ATTACHMENT : RESIDENTIAL ZONES - DCP ASSESSMENT

## ATTACHMENT B – DCP TABLE

<p>Extract from site plan and perspective – screen locations fronting Beach Road:</p>

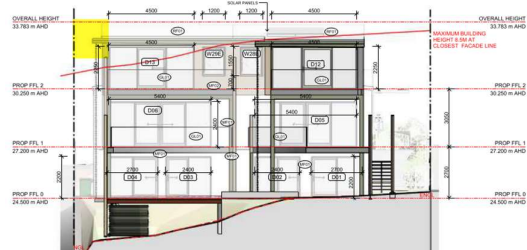
P1	A1. Front 7m, (30m unsealed), Side 5m, Rear 5m	<input type="checkbox"/>	<input type="checkbox"/>	<input checked="" type="checkbox"/>																													
P2	A2.1 Dwelling- 20% Avg & no smaller than existing	<input type="checkbox"/>	<input checked="" type="checkbox"/>	<input type="checkbox"/>	<p><b>Dwelling:</b> <b>Required:</b> 5m i.e. adjacent dwellings allow front car parking and maneuvering areas as evident on aerial photographs. Measurement by Council on survey plan of No. 217 Beach Road measures garage setback of 5m: <b>Proposed:</b> 1.5m (car park/building vertical wall screens)</p>

<p><b>s8.2 review – the review documents do not change the assessment under DA0095-24.</b></p> <p>Note: the DCP adopts LEP definitions for building setbacks. ELEP Building setback means:</p> <p><b>building line or setback</b> means the horizontal distance between the property boundary or other stated boundary (measured at 90 degrees from the boundary) and—</p> <p>(a) a building wall, or</p> <p>(b) the outside face of any balcony, deck or the like, or</p> <p>(c) the supporting posts of a carport or verandah roof,</p> <p>whichever distance is the shortest.</p> <p><b>Garage/carport:</b>          Required: 5.5m          Proposed: 1.5m.  <b>Does not comply.</b>          The proposal includes screen walls located 1.5m from the front boundary which extend past the first floor balcony, and meet the definition for building setback building elements.</p> <p><b>The proposal fails to meet the intent and objectives of this section.</b></p> <p><b>Intent:</b>          To minimise adverse impacts on the streetscape and surrounding properties and to minimise the visual impact of development on reserves and cliff-tops.</p> <p><b>Performance objectives:</b>          P2 Buildings are setback to contribute to the existing or proposed streetscape character, assist in the blending of new development into the streetscape, make efficient use of the site and provide amenity for residents.</p>

<p>Ground floor:</p> <p>First floor (level 2):</p> <p>Above 7.5m – required 2m setback</p> <p><b>As-built structures –</b>  <u>s8.2 review – the applicant has sought the use of as-built structures under this application.</u></p> <p>A site inspection identified structures have been built at the beach area including retaining walls and stairs/walkways. These are not considered to meet the overall intent or performance criteria in relation to setbacks (side and rear) given the scale of the structures.</p> <p>The s8.2 review documents illustrate removal of a previously proposed beach shed on an elevated earthen filled platform area (large retaining walls) (now replaced by an extended deck area elevated on retaining walls) that result in large structures and built form in close proximity to site boundaries that are not consistent with the scale of development along the beach foreshore area, or the requirements of this section, including side setbacks.</p> <p><b>s8.2 review – the review documents do not change the findings of the assessment under DA0095-24.</b></p> <p><b>The proposal fails to meet the intent and objectives of this section.</b></p>

Extract from site analysis plan with adjoining buildings highlighted: - **s8.2 review plans:**

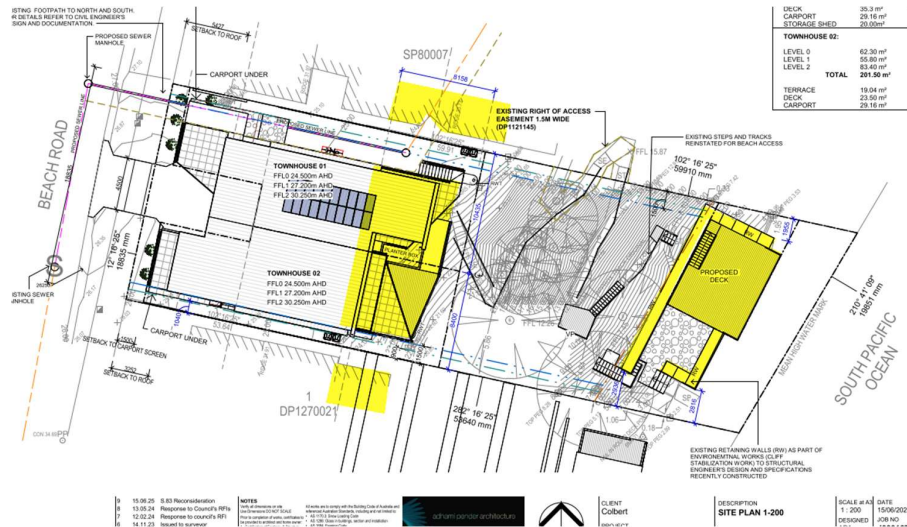
The development approved along this section of Denhams Beach relies on an average setback. The submitted plans illustrate the proposal for the dual occupancy has considered the rear setback in relation to adjoining dwellings. It is noted that adjoining buildings project beyond the cliff top edge, **however the structures at the base of the cliff are not considered to meet the intent or performance criteria of this section.**

A site inspection identified structures have been built at the beach area including retaining walls and stairs/walkways. **These are not considered to meet the overall intent or performance criteria in relation to setbacks (side and rear) given the scale of the structures.**

The submitted plans illustrate an elevated deck area to be constructed on the as-built retained platform at the base of the cliff on elevated earthen filled platform area (large retaining walls) that result in large structures and built form in close proximity to site boundaries that are not consistent with the scale of development along the beach foreshore area, or the requirements of this section, including side setbacks.

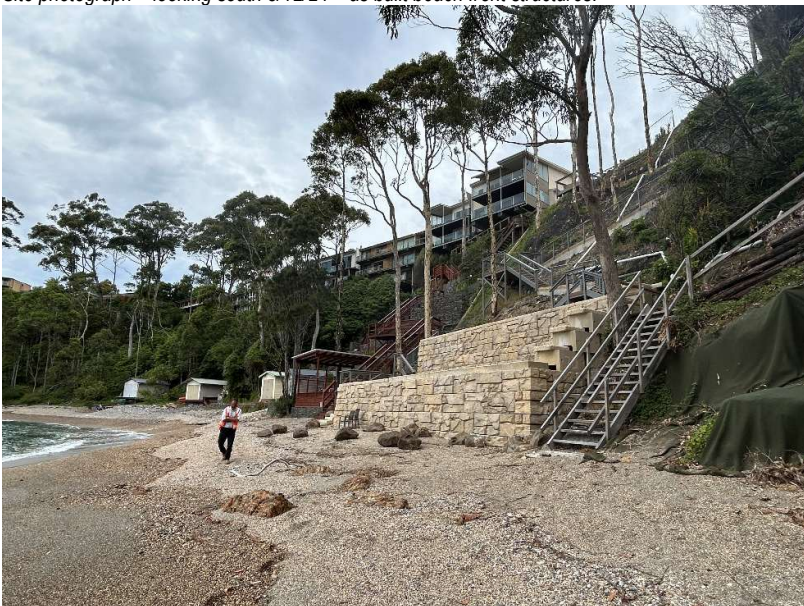
Refer comments above in the 'Front setback' section of this report. The proposal involves large 1-2 storey screens to the front streetscape that fail to consider the design in relation to adjoining residential properties and the streetscape.

**s8.2 review – the review documents do not change the findings of the assessment under DA0095-24.**

**The proposal fails to meet the intent and objectives of this section.**
